AGENDA
PLANNING AND ZONING COMMISSION MEETING
CITY OF CREVE COEUR, MISSOURI
MONDAY, NOVEMBER 2, 2015
7:00 PM

1. Application #14-022: Revised Site Development Plan Approval at the Shoppes at Westgate

**APPLICATION TO PLANNING AND ZONING COMMISSION
#14-022 FOR REVISED SITE DEVELOPMENT PLAN APPROVAL
AT THE SHOPPES AT WESTGATE**

Figure 3: Close-up of the new building entrance element.

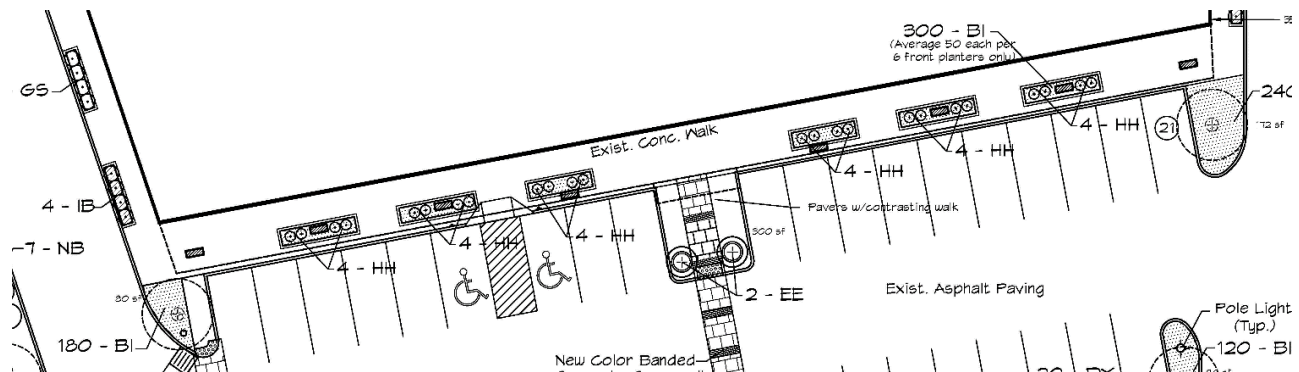
Staff finds the shortening of the entry element, only further highlights the de minimis entry element and the loss of the focal point of the building. Removing the stone columns shifts the focus of the building towards the two ends. The proposed alteration does not have an equivalent prominence of the stone columns that balanced the overall building, where the Design Guidelines recommend that building designs should incorporate a clear and well-articulated design concept, and presence. Staff suggests keeping the existing feature, or in the alternative, enlarging the proposed bracketed arched feature so that it provides an equivalent focal architectural element that is in proportion to the building. In earlier discussions with the Applicant, Staff had suggested a trellis type design that would allow for a lighter support structure, provided that it is wide enough create a visual balance with the building.

Figure 4: Close-up of the proposed landscape plan along Olive Boulevard.

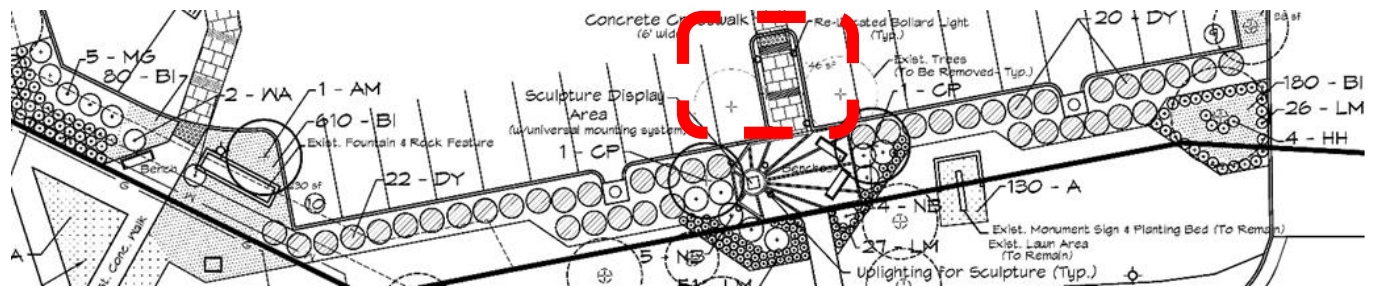
The Landscaping is consistent with the minimum requirements of a green line park and the requirements of Section 405.540 Landscaping of the City's Zoning Ordinance and Section 405.810(5), with a straight line of evergreen hedge along the parking area when adjacent to the right-of-way. But it lacks the diversity of the prior landscape plan relied on in prior approval for site coverage bonus, as shown below. The Applicant is providing for additional plantings at the corner, however, the area along the parking spaces in particular lacks a variety of plant design.

5. A final landscape plan shall be submitted that provides for additional plantings and diversity along Olive Boulevard frontage adjacent to the parking area prior to the issuance of site improvement permits.

Figure 6: Close up of the Sculpture Display Area and Seating area

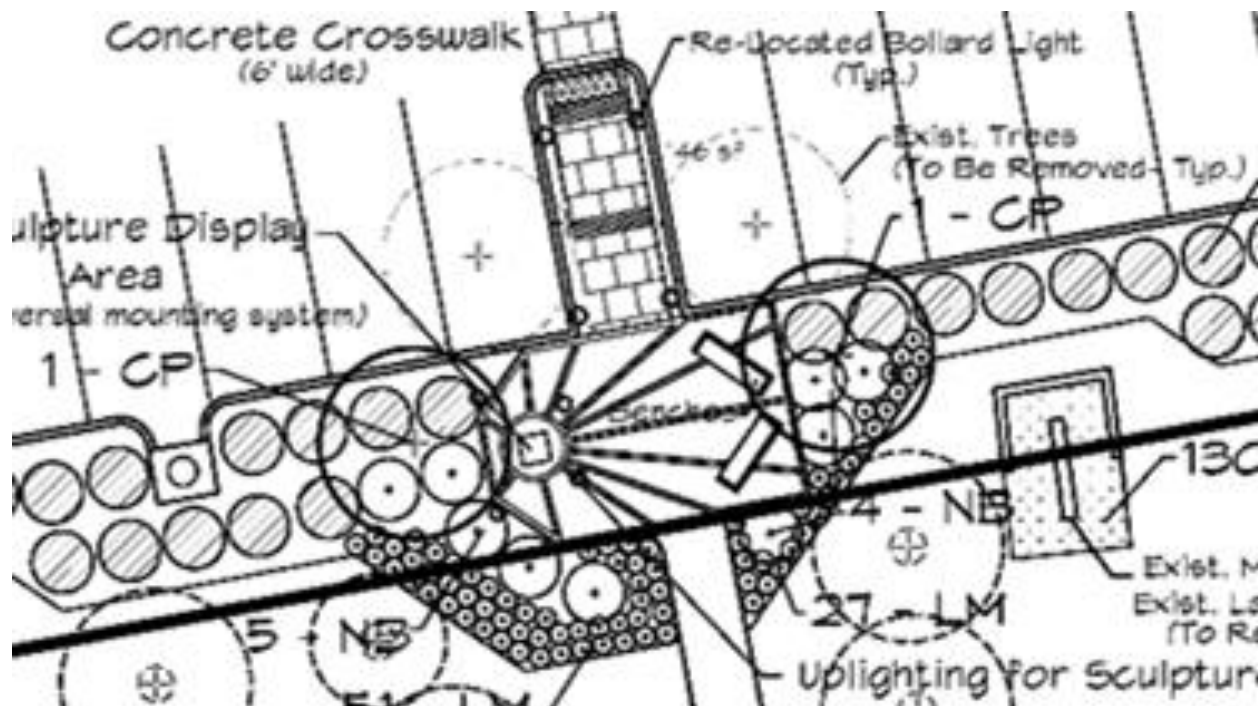
The inclusion of the public art is a new feature and includes relocation of the existing plaza seating area that existed between the parking spaces. However, Staff recommends that it be slightly expanded to equate to the size of the former pedestrian area and to allow more room for viewing of the art pieces.

Figure 6: Close-up of northeast corner area of the existing fountain, proposed bench and flagpoles.

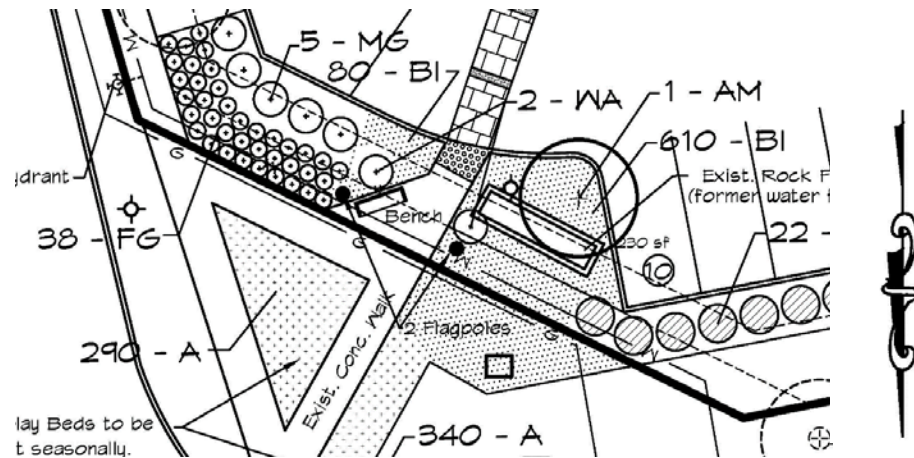
The current proposal includes replacing with new landscaping (some of which is within MODOT right-of-way), adding the bench seating and two flag poles at the northeast corner per the drawing below:

Figure 7: Close up of the proposed changes to the plaza area at the front/entrance of the building.

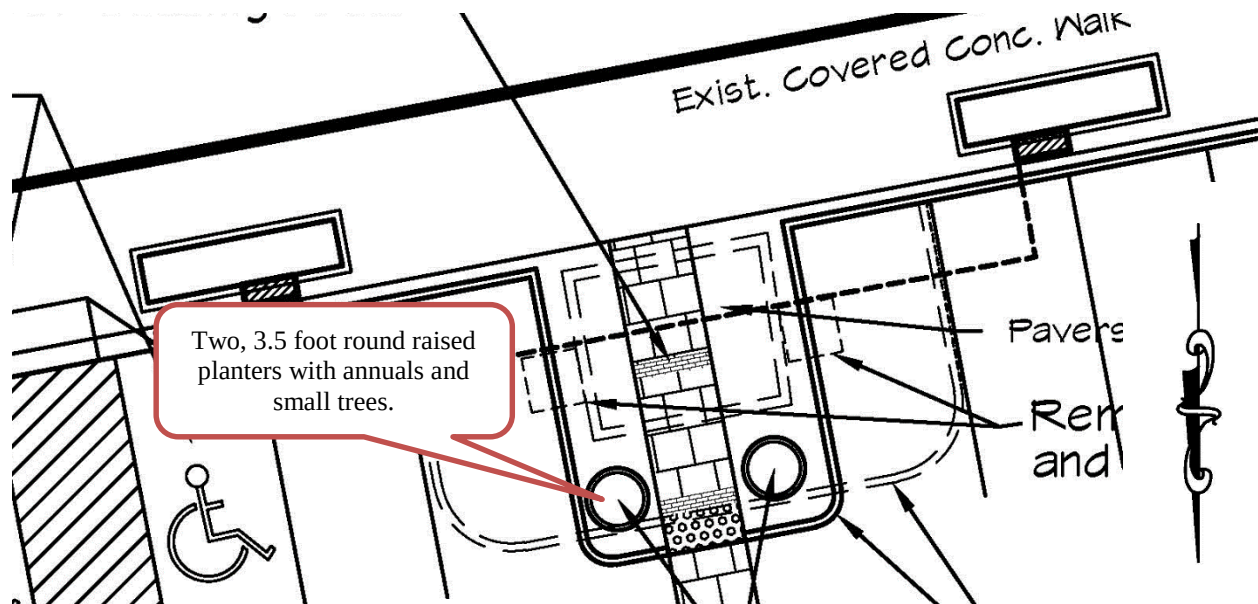
The plaza/dining area proposal include removing the existing planters, narrowing the overall space and adding two round raised planter with annuals and small ornamental trees:

2. Pedestrian open spaces, such as covered walkways, courtyards, and plazas, are encouraged. While the planter in the middle of the existing plaza limits the outdoor dining area, the narrowing of the plaza area for more parking is counter to the Design Guidelines. The remaining plaza area appears under-scaled with the site and limits the purposes even further than the current design. Simply maintaining the existing width of the plaza area and removing the planter to allow for more seating would greatly enhance the proposed plaza area.

Figure 8: Close-up of the Site Plan of the middle sidewalk from Olive to the building entrance.

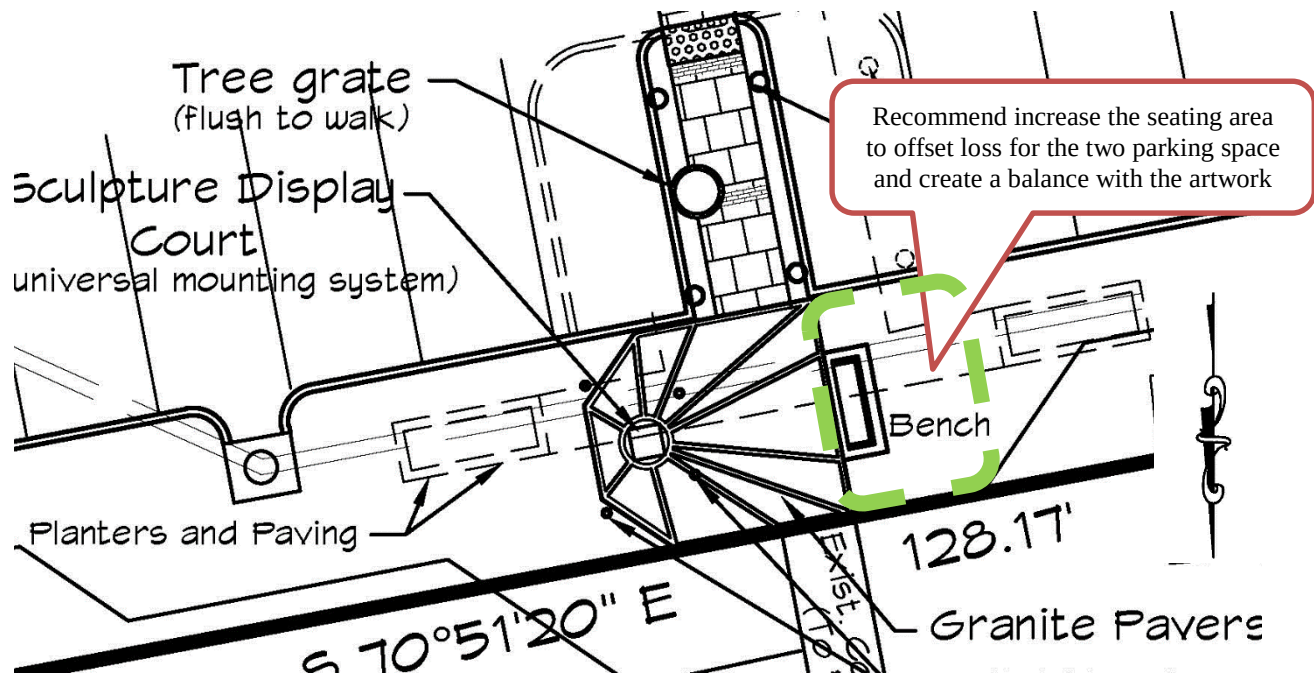
Section 405.730(A)(2) of the Zoning Ordinance states that the minimum width of internal sidewalks in non-residential developments shall be at least six feet or eight feet if used as a curb stop. The site plan indicates that the sidewalks are five feet in width. However, they are not adjusting most of the sidewalks already on site. However the pedestrian connection within the newly created plaza seating is maintaining a five foot path, and across the drive aisle along Olive, and the tree grate narrows it further to three feet, per the image below:

Staff recommends that any new sidewalk area shall have a minimum of six feet in width to meet with the minimum standards of the Code. As mentioned above the location of two tree may be moved to in front of the stall and low landscaping provided on either side of the walkway. The loss of plaza seating at this location should be shifted to sculpture display area, by increasing the seating area and create balance.
